Access Compliance Report Public Rights-of-Way (Curb Ramps)

Main Street: WALDEN_ST Cross Street: SIENNA_PKWY Location: NW

ADA ID: RPRK211020172222 Ramp Type: Type 1 - Perpendicular Diagonal Initial Pass/Fail: Fail Overall Compliance: No Severity Score: 15

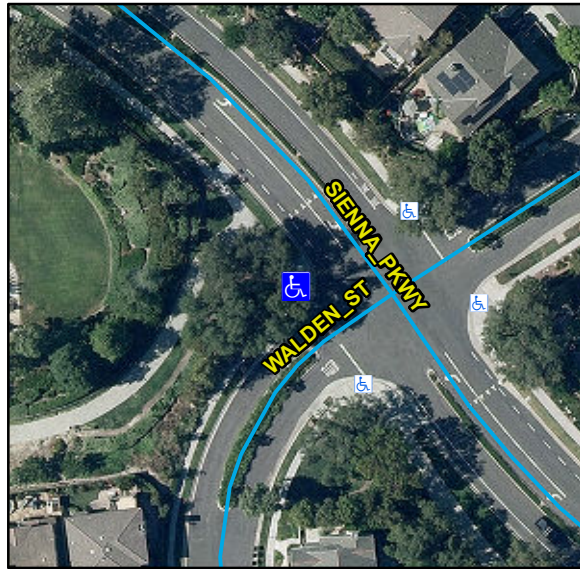
R304.2.2, R204.3, STD 1115

Remove & Replace Curb Ramp With Two New Directional Ramps or Equivalent. Restripe Crosswalk.
